Evanston Ecology Center Renovation

BID # 23-55

ADDENDUM No. 04

This addendum forms a part of the Bid documents for Bid # 23-55 and modifies these documents. This addendum consists of the following:

Figure 1 S-102

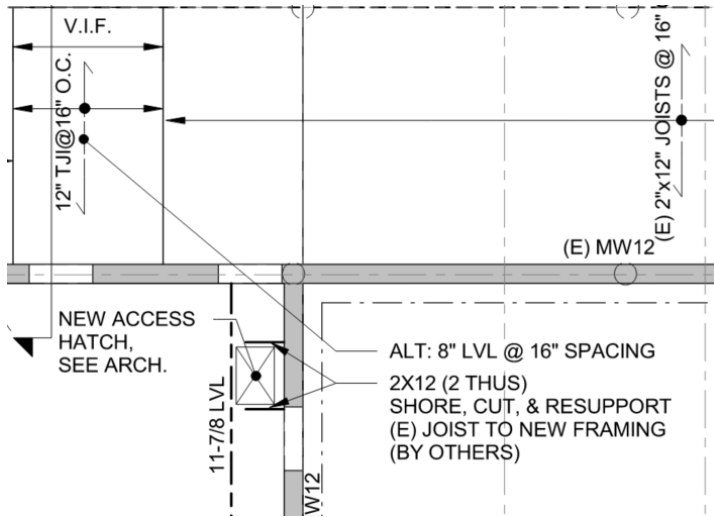
8. **Question:** Can you provide clarification on the specific scope of work surrounding the crawl spaces and flooring replacement scopes. It appears there are call outs that indicate Alternate work in the multipurpose room. However, this alternate would encompass floor demolition and replacement. Any further specifics of the crawl space and flooring replacement plan, particularly regarding the reuse of floor joists and the handling of columns in terms of excavation, extension, and replacement as per Figure 1 from S-102?

Response: Alternate crawl space work in the multipurpose room would match A501/1. Structural questions addressed by question 15.

Figure 3 AD-102

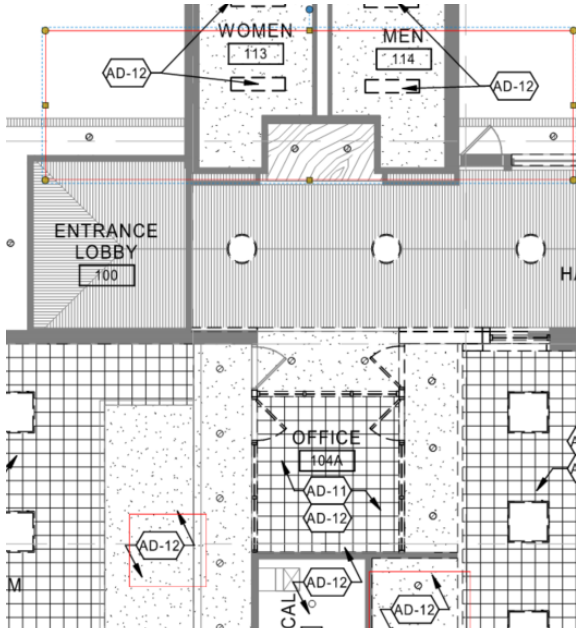
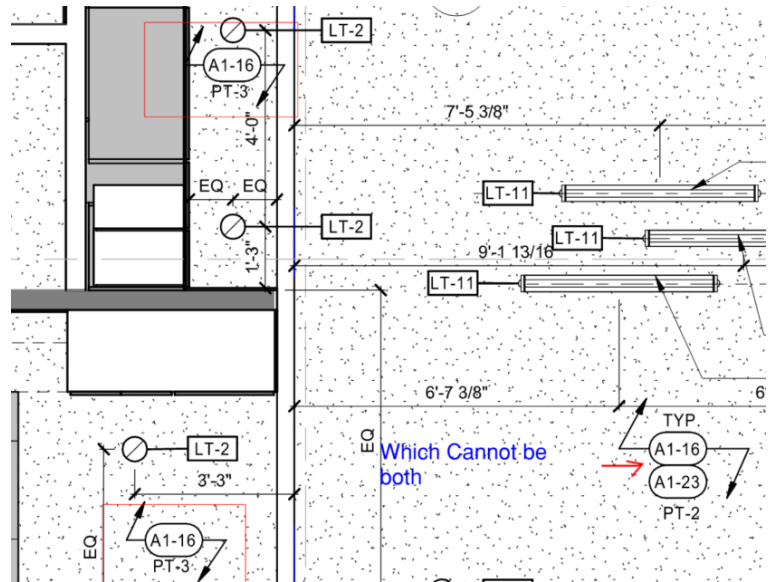
10. **Question:** Plan conflict between Demolition and RCP: The conflicting instructions between AD-102 (Figure 2) and A-121 (Figure 3) concerning the treatment of existing interior lighting fixtures and the installation versus repair of gypsum ceilings? Can you provide clarification on the conflicting notes in A-121 regarding the installation of a new gypsum ceiling versus the repair and patching of the existing ceiling, especially in areas specified by note A1-23 where ACT is being removed?

Response: Keynote AD-12 refers to existing interior light fixtures, and is not related to the demolition or installation of new ceilings. In the classroom and office, the identified ceiling tile is surface applied to a gyp. ceiling. These tiles are to be removed and a new layer of gyp. is to be laminated to the existing one and painted per the finish schedule and RCP.

SHEET ID
A121

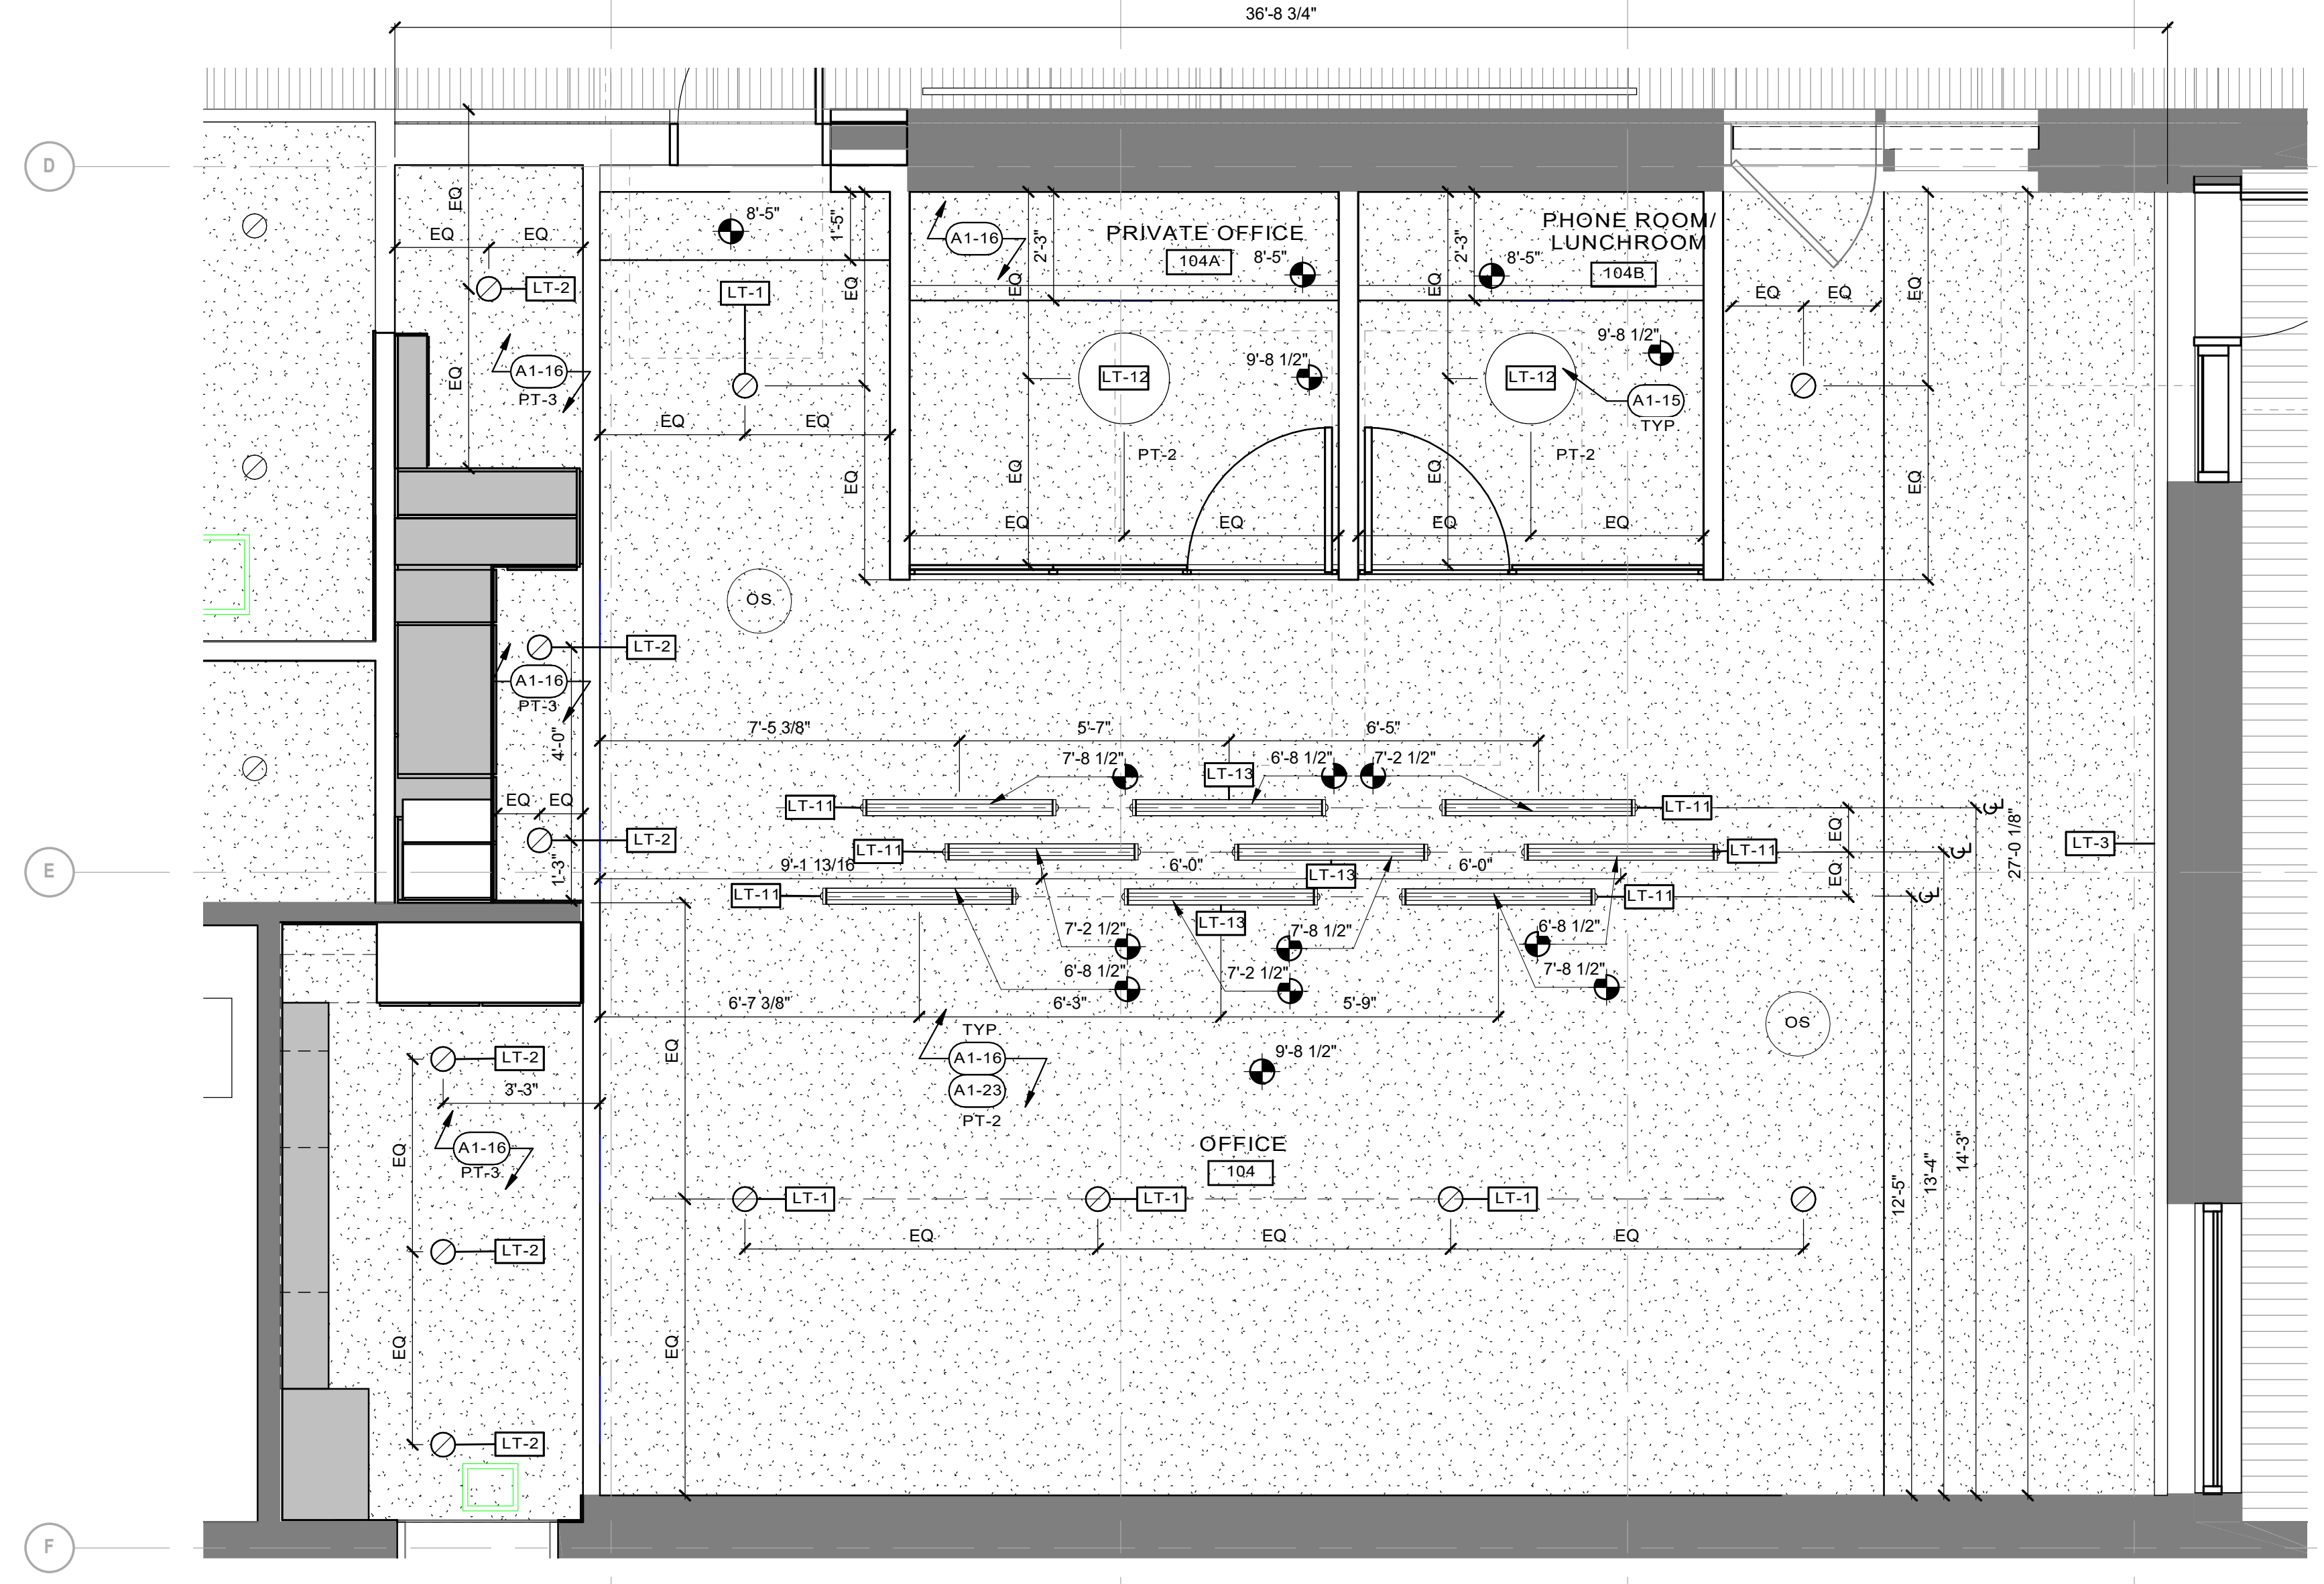
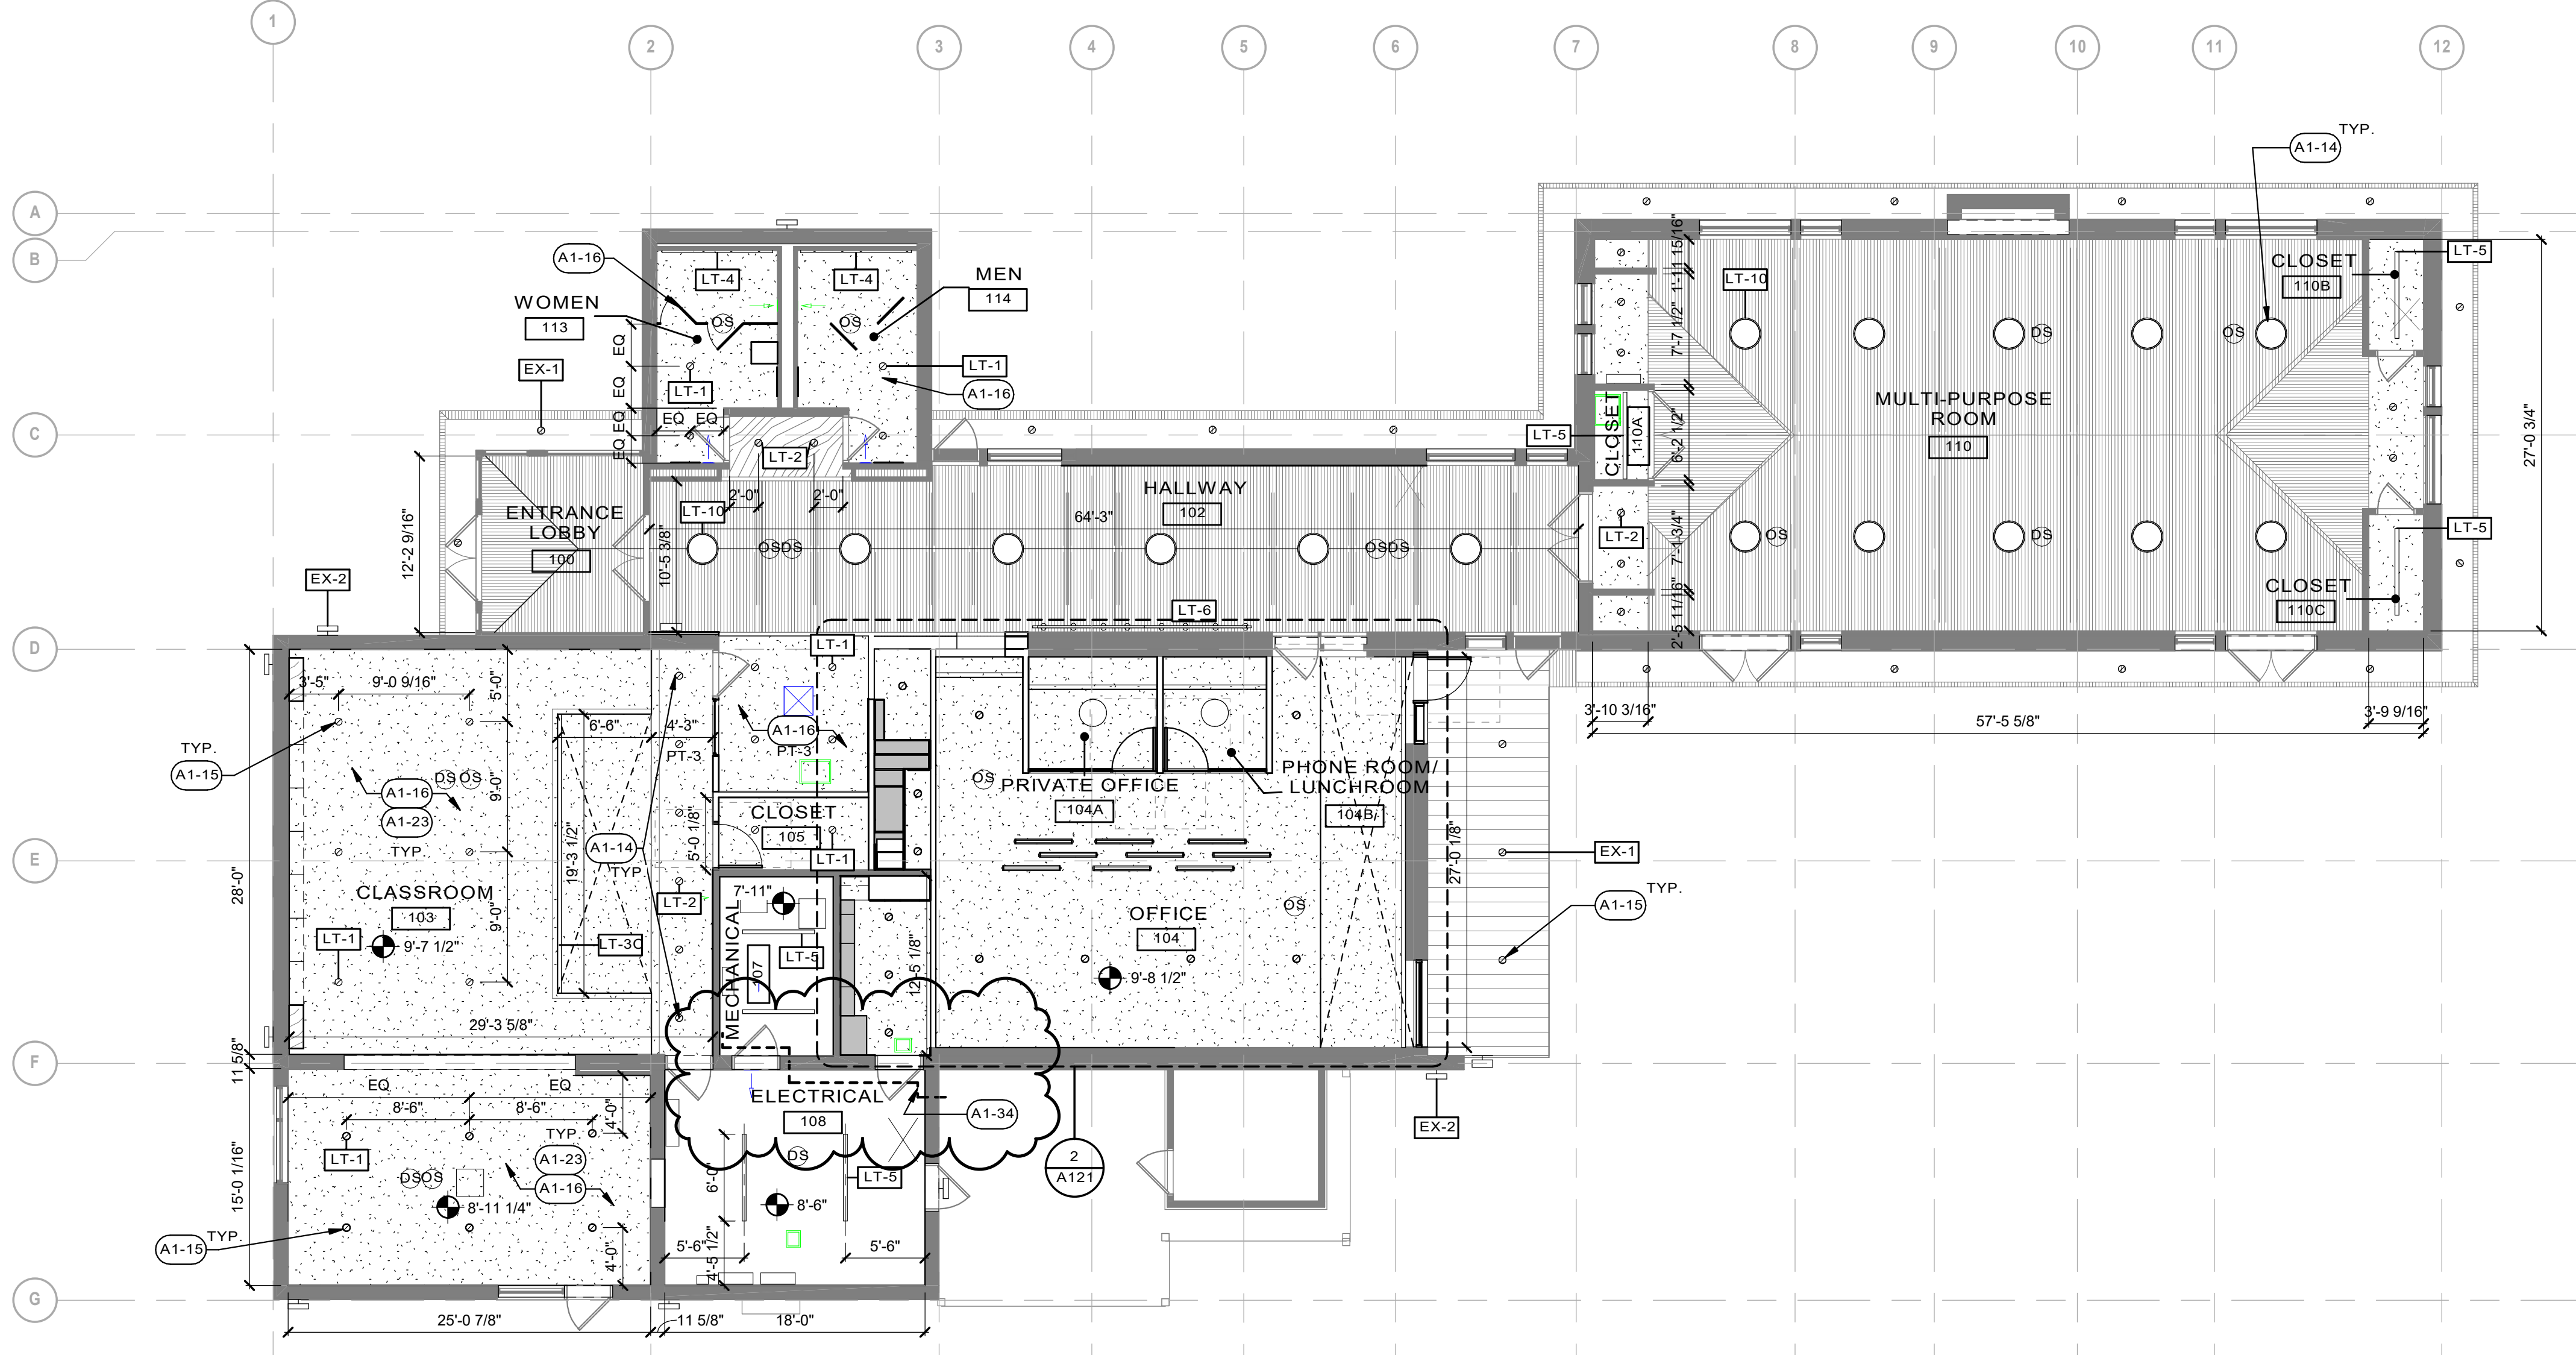
1. **Question:** Is there any additional information that can be provided about the Fiber Optics Cable?

28. **Question:** Can we have an image of the fiber cable that will remain undisturbed? And a rough route of this cable through the space?

31. **Question:** Will you issue an updated lighting schedule, the one on E102 isn't legible, and there aren't designations on each fixture.

Response: Please see revised drawing A102 Reflected Ceiling Plan. The data traveling the Fiber Optics Cable is sensitive in nature. The contractor will be responsible for **one thousand, five hundred dollars (\$1,500) per hour in liquidated damages** for any disruption in this data link. Temporary disruption of the data link is not an option. The contractor will be responsible for protecting the cable and the splicing device. The City will entertain moving the cable and the splicing device within the limits of the excess wire and within the same room. The contractor is not permitted to perform this work, but must coordinate with City staff to perform.

Response: Refer to Sheet A121
